Class 3 Permit Modification Request

Excavation of a New Shaft and Associated Connecting Drifts

**Waste Isolation Pilot Plant
Carlsbad, New Mexico**

WIPP Permit Number - NM4890139088-TSDF

**Figure A2-1
Repository Horizon**

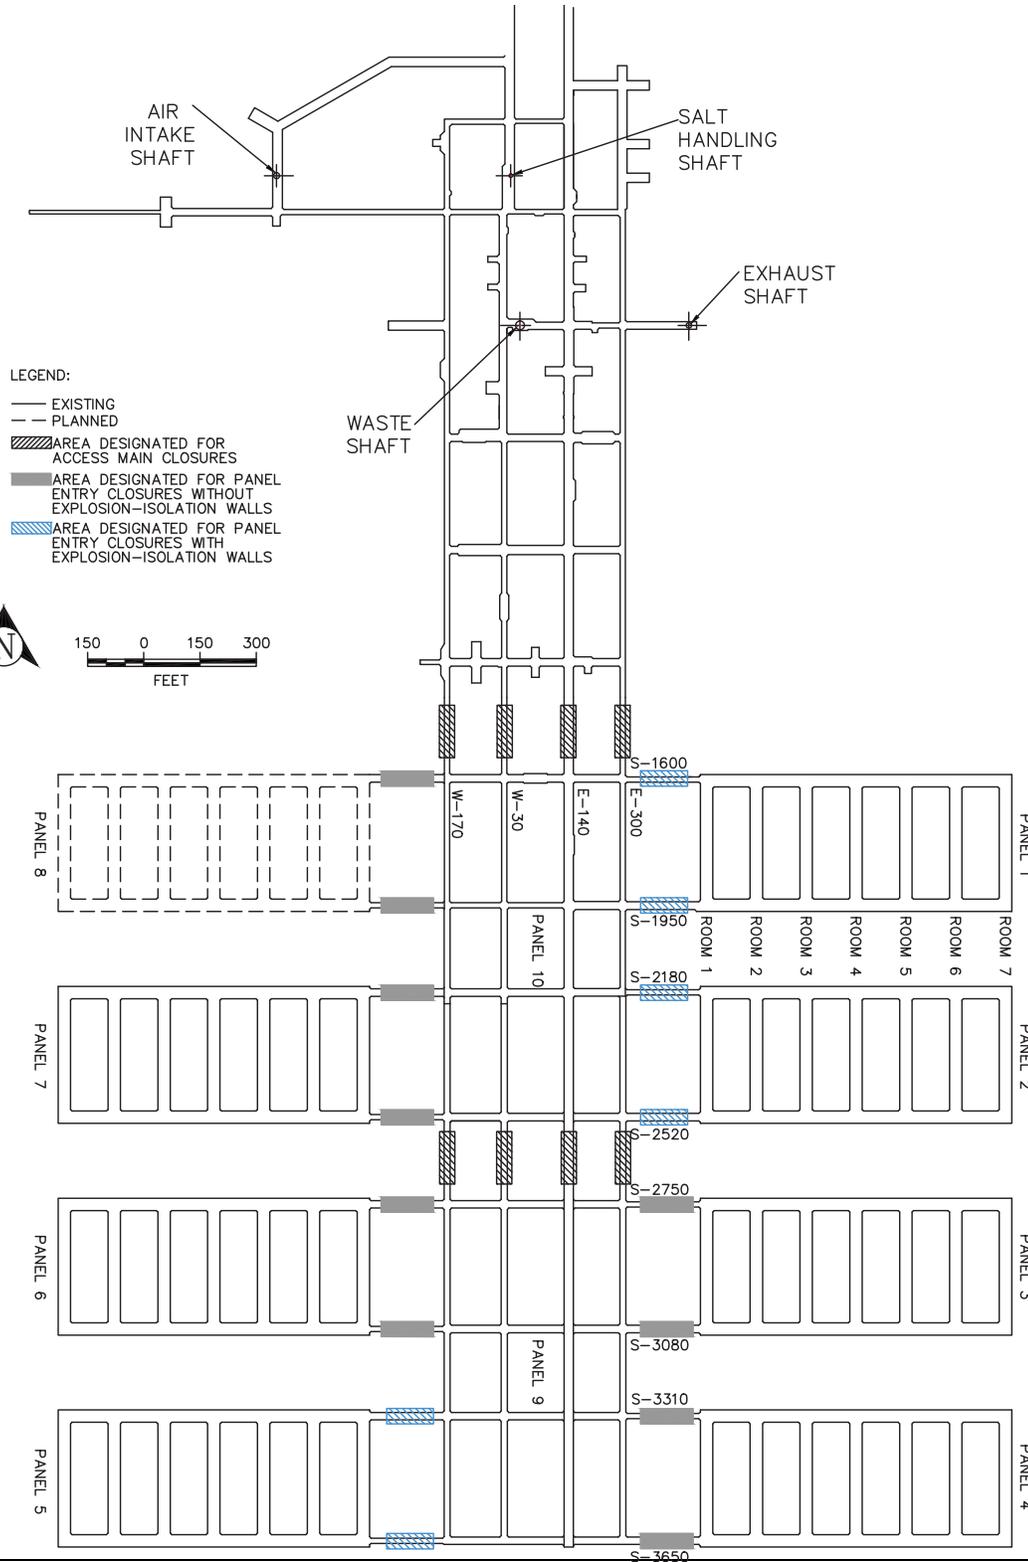
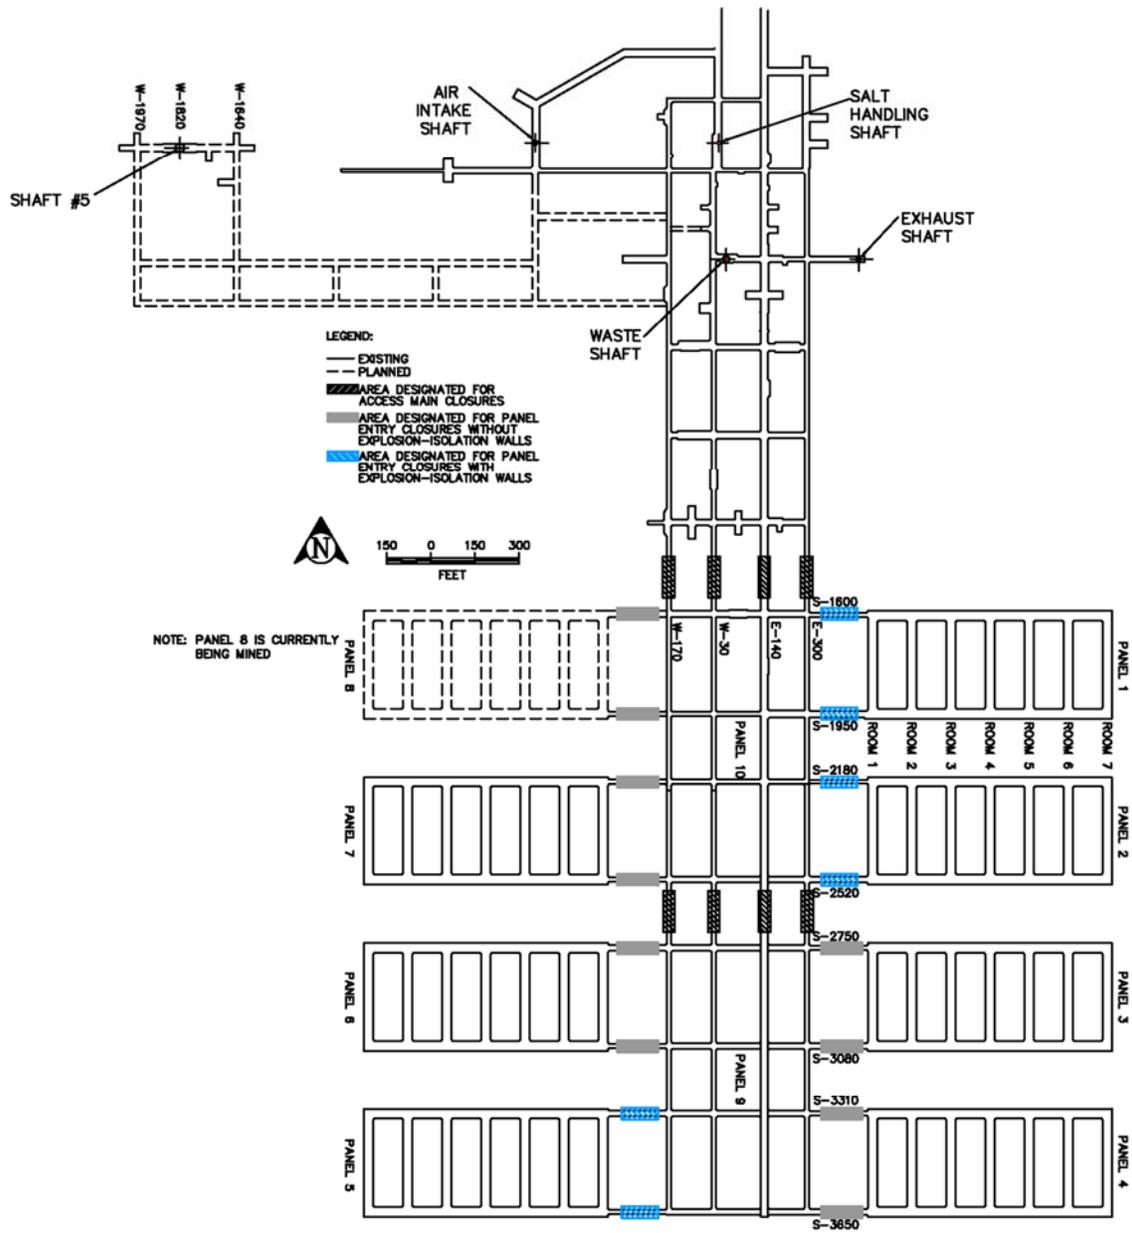
Affected Permit Section	Explanation of Change
Attachment A2, Figure A2-1	Replaced Figure A2-1 <i>Repository Horizon</i> with new figure.
Attachment A2, Figure A2-2-S#5	Added new Figure A2-2-S#5, <i>Spatial View of the Miscellaneous Unit and Waste Handling Facility (with S#5)</i> , after Figure A2-2.
Attachment A2, Figure A2-9c	Added new Figure A2-9c, <i>Underground Ventilation System Airflow (with S#5)</i> , after Figure A2-9b.
Attachment A4, Figure A4-4	Replaced Figure A4-4, <i>Typical Underground Transport Route Using E-140</i> , with new figure.
Attachment A4, Figure A4-4a	Replaced Figure A4-4a, <i>Typical Underground Transport Route Using W-30</i> , with new figure.
Attachment B, Table of Contents	Added entry for Figure B3-1-S#5, <i>Spatial View of the WIPP Facility (with S#5)</i> , to Table of Contents, Appendix B3 Facilities.
Attachment B, Appendix B2, Figure B2-2	Replaced Figure B2-2, <i>Planimetric Map-WIPP Facility Boundaries</i> , with new figure.

Figure A2-2-S#5
Spatial View of the Miscellaneous Unit and Waste Handling Facility (with S#5)

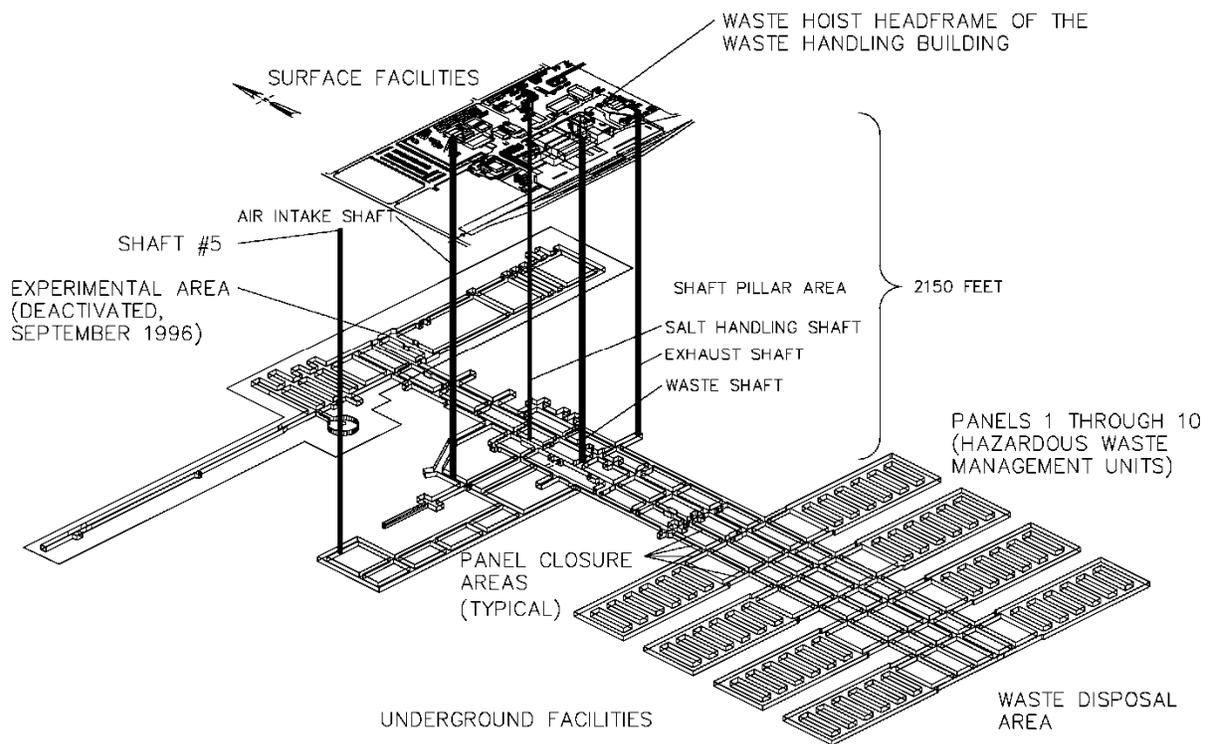
Attachment A2, Figure A2-2-S#5	The <i>Spatial View of the Miscellaneous Unit and Waste Handling Facility (with S#5)</i> figure is being added to show the location of S#5 and the planned connecting drifts in relation to the existing underground facility. This change is needed to update the Permit with the information pertaining to S#5.
Attachment A2, Figure A2-9c	Figure A2-9c, <i>Underground Ventilation System Airflow (with Shaft #5)</i> is being added to show the repository ventilation flow with S#5. This change is needed to update the Permit with the information pertaining to S#5.
Attachment A4, Figure A4-4	The <i>Typical Underground Transport Route Using E-140</i> figure is being modified to show the location of S#5 along with the planned drifts to connect the shaft to the underground facility. This change is needed to update the Permit with the information pertaining to S#5.
Attachment A4, Figure A4-4a	The <i>Typical Underground Transport Route Using W-30</i> figure is being modified to show the location of S#5 along with the planned drifts to connect the shaft to the underground facility. This change is needed to update the Permit with the information pertaining to S#5.

Figure A2-9c
Underground Ventilation System Airflow (with S#5)

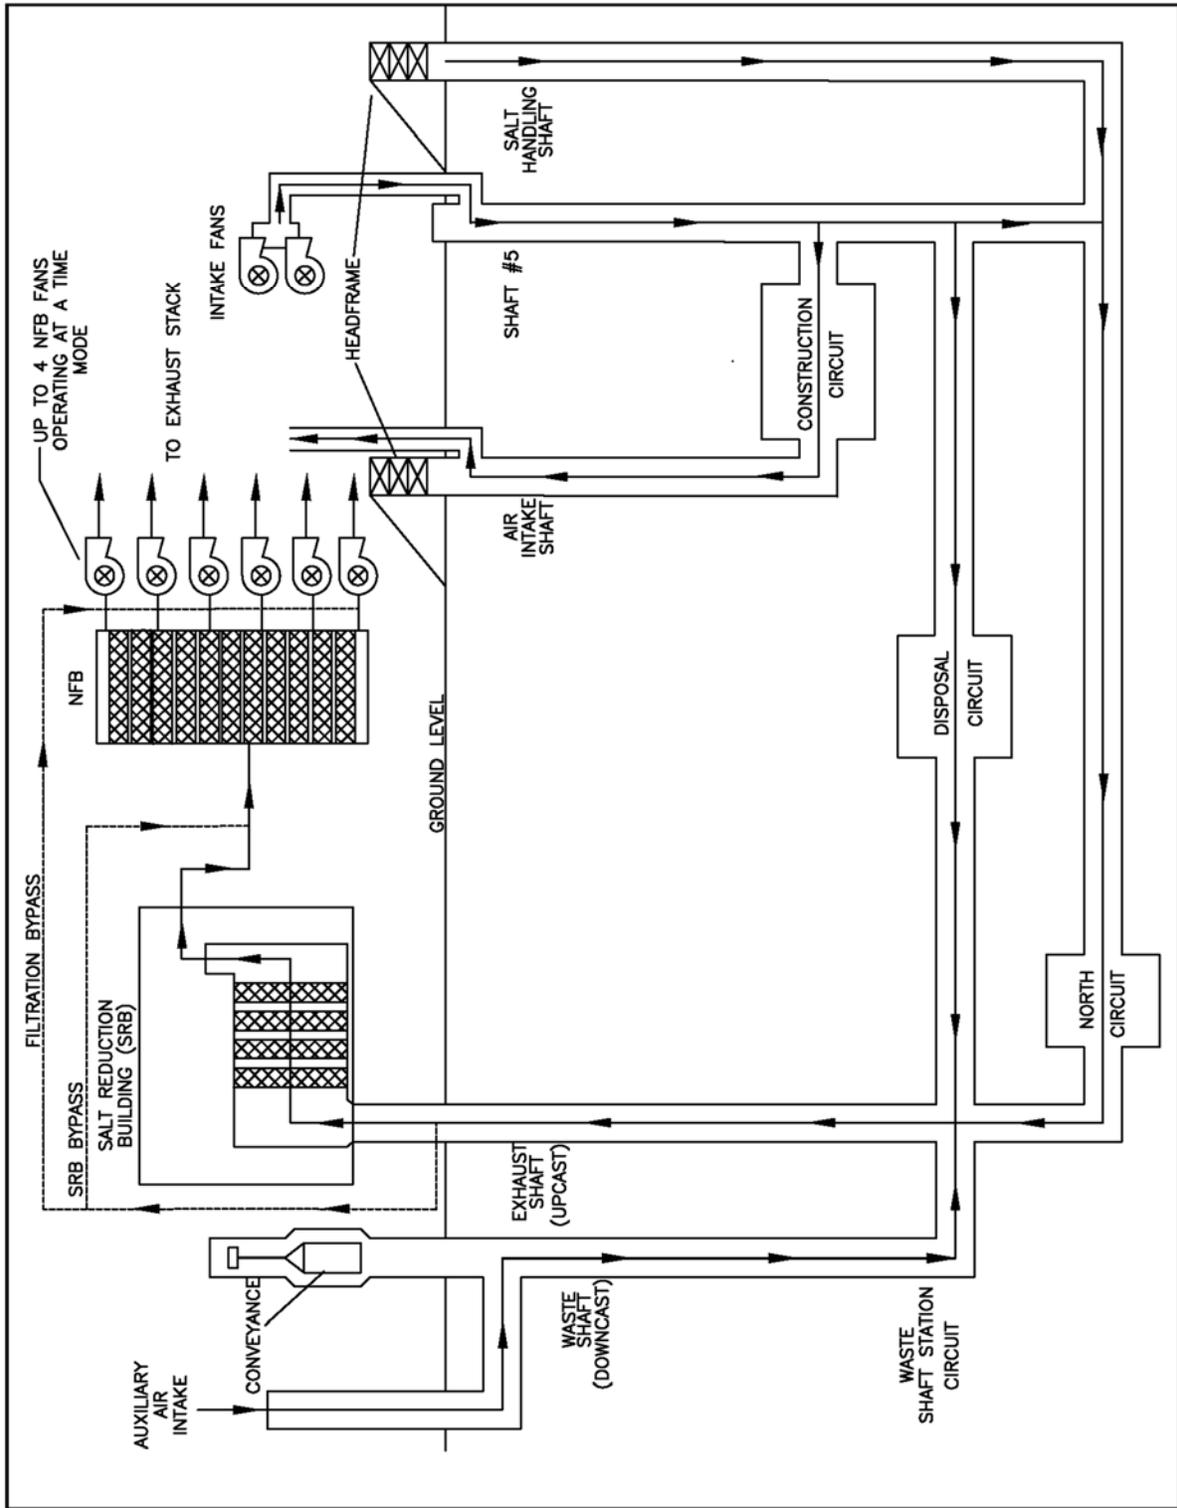
Attachment A2, Section A2-2a(3), <i>Subsurface Structures</i>	<p>Added new paragraph “With S#5 in use (Figure A2-9c), the Salt Handling Shaft serves as the secondary supply-air pathway for the underground facility while S#5 serves as the primary supply-air pathway for the underground facility. The Waste Shaft supplies the intake air for the Waste Shaft Station. The Air Intake Shaft provides the exhaust route for the Construction Circuit while the Exhaust Shaft provides the exhaust route for the North, Disposal, and Waste Shaft Station Circuits.” after second paragraph under subsection <i>Underground Facilities Ventilation System</i>.</p> <p>Added new paragraph “When the repository is configured to use five shafts, two fans located on the surface and connected via ducting and a plenum to S#5, supply the majority of the intake air to the underground facility. One fan operates at a time, while the idle fan is available as a back-up fan. The Salt Handling Shaft serves as a secondary air intake shaft for the north area and the Waste Shaft serves as the air intake shaft for the waste shaft station area of the underground facility. The Air Intake Shaft serves as an unfiltered exhaust shaft for the construction area of the underground facility. The north, disposal, and waste shaft station areas of the underground facility are exhausted through the Exhaust Shaft and the associated filtration system.” after first paragraph under subsection <i>Underground Ventilation System Description</i>.</p> <p>Added “standard” after “minimum ventilation rate of 35,000.”</p> <p>Added “When the repository is configured to use four shafts,” to the first paragraph under subsection <i>Underground Ventilation Modes of Operation</i>.</p> <p>Added new paragraph “When the repository is configured to use five shafts, two intake fans located on the surface and connected to S#5 via ducting and a plenum, supply the majority of the intake air to the underground facility. The fans are designed to operate one fan at a time with the second fan available as a back-up fan. The fans have variable frequency drives that can adjust the intake flow at S#5 to meet the requirements of the underground ventilation filtration system and the Construction Circuit.” after third set of bullets under subsection <i>Underground Ventilation Modes of Operation</i>.</p>

With S#5 in use (Figure A2-9c), the Salt Handling Shaft serves as the secondary supply-air pathway for the underground facility while S#5 serves as the primary supply-air pathway for the underground facility. The Waste Shaft supplies the intake air for the Waste Shaft Station. The Air Intake Shaft provides the exhaust route for the Construction Circuit while the Exhaust Shaft provides the exhaust route for the North, Disposal, and Waste Shaft Station Circuits.

Figure B2-2
Planimetric Map-WIPP Facility Boundaries

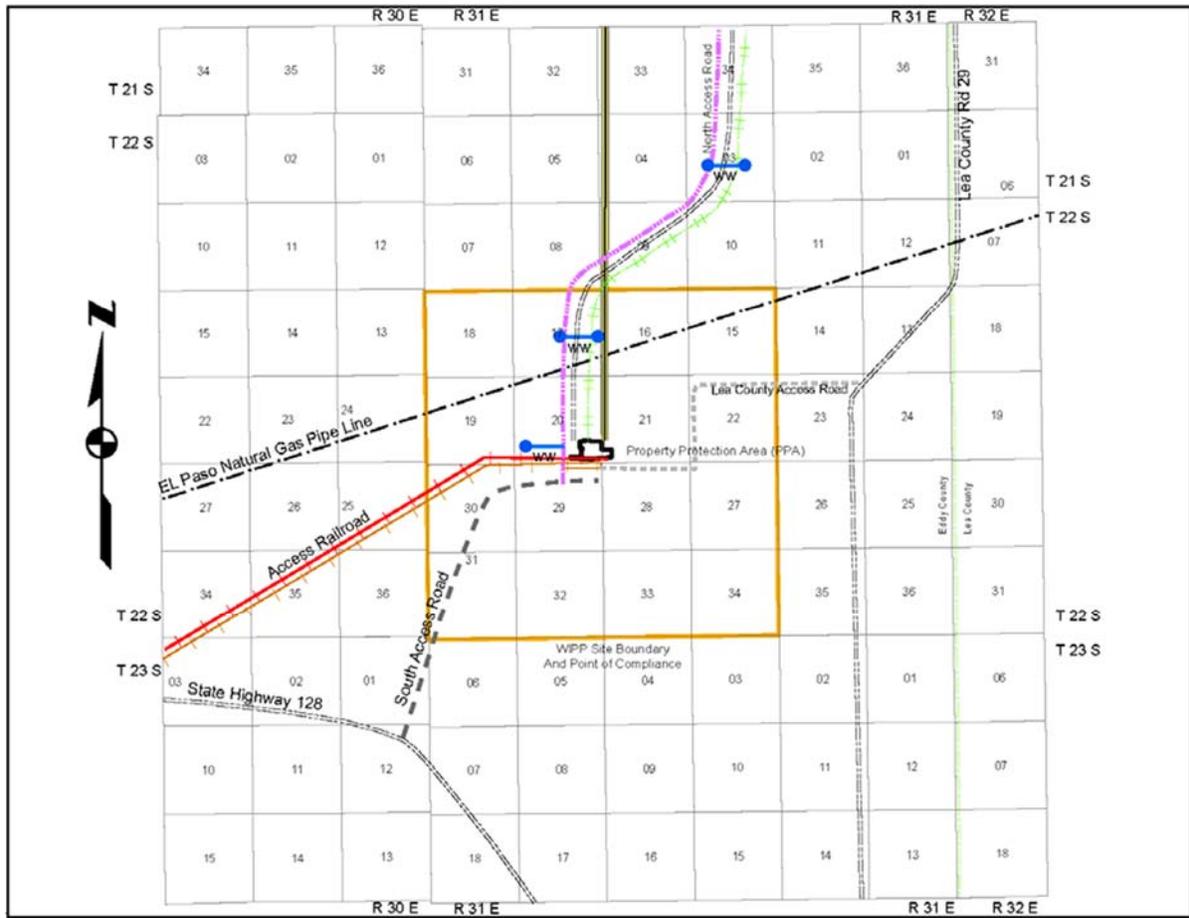
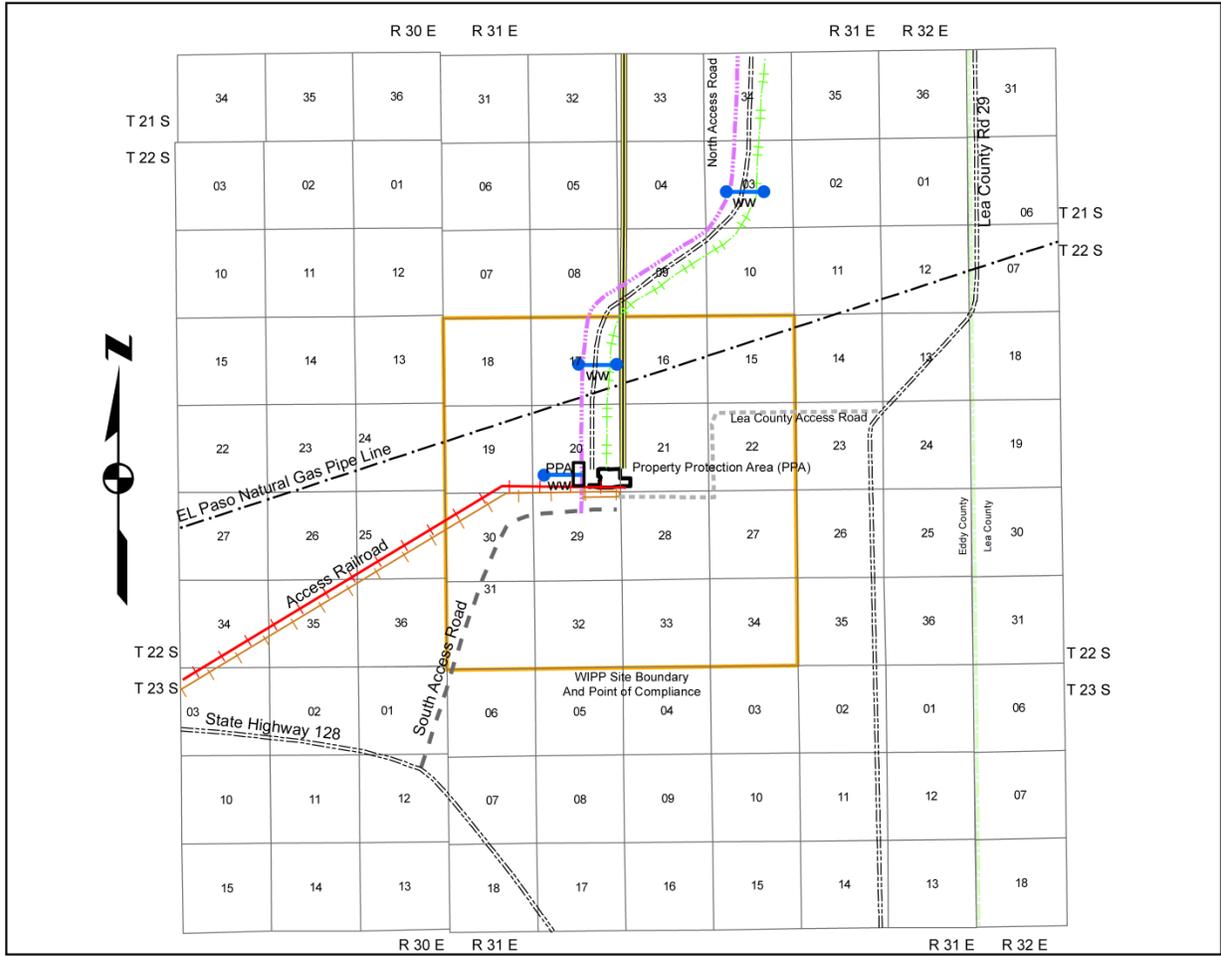
- Figures in Attachment B, Appendix B2 and B3 are being modified or added to show the location of S#5 and the planned connecting drifts.
 - Figure B2-2 and Note 2 in Figure B2-2a is being replaced to address the addition of a second PPA encompassing the area around S#5.

Attachment B, Figure B2-2	The <i>Planimetric Map-WIPP Facility Boundaries</i> figure is being modified to show the additional PPA around S#5. This change is needed to update the Permit with the information pertaining to S#5.
Attachment B, Figure B2-2a	The <i>Legend to Figure B2-2</i> figure is being modified to describe the additional PPA area around S#5 in the "Notes" section of the figure. This change is needed to update the Permit with the information pertaining to S#5.
Attachment B, Figure B3-1-S#5	The <i>Spatial View of the WIPP Facility (with S#5)</i> figure is being added to show the spatial view of the facility with S#5 and the planned connecting drifts. This change is needed to update the Permit with the information pertaining to S#5.
Attachment B, Figure B3-2	The <i>Repository Horizon</i> figure is being modified to show the location of S#5 along with the planned drifts to connect the shaft to the underground facility. This change is needed to update the Permit with the information pertaining to S#5.

Figure B3-1-S#5
Spatial View of the WIPP Facility (with S#5)

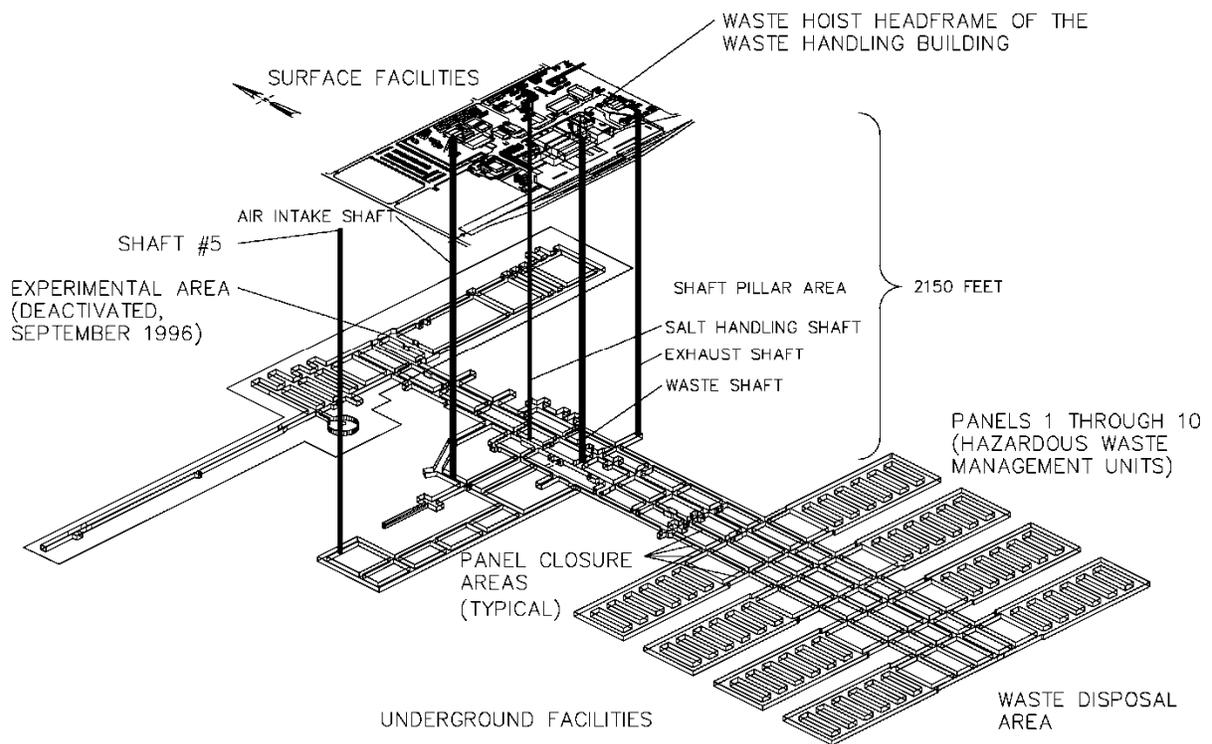
Attachment B, Appendix B2, Figure B2-2a	Replaced Figure B2-2a, <i>Legend to Figure B2-2</i> , with new figure.
Attachment B, Appendix B3, Figure B3-1-S#5	Added new Figure B3-1-S#5, <i>Spatial View of the WIPP Facility (with S#5)</i> , after Figure B3-1.
Attachment B, Appendix B3, Figure B3-2	Replaced Figure B3-2, <i>Repository Horizon</i> , with new figure.
Attachment D, List of Figures	Added entries for Figure D-2-S#5, <i>Spatial View of the WIPP Facility (with S#5)</i> , and Figure D-5-S#5, <i>Fire-Water Distribution System (with S#5)</i> , to Table of Contents.
Attachment D, Figure D-2-S#5	Added new Figure D-2-S#5, <i>Spatial View of the WIPP Facility (with S#5)</i> , after Figure D-2.
Attachment D, Figure D-3	Replaced Figure D-3, <i>WIPP Underground Facilities</i> , with new figure.
Attachment D, Figure D-5-NFB	Replaced Figure D-5-NFB, <i>Fire-Water Distribution System with Building 416</i> , with new figure.
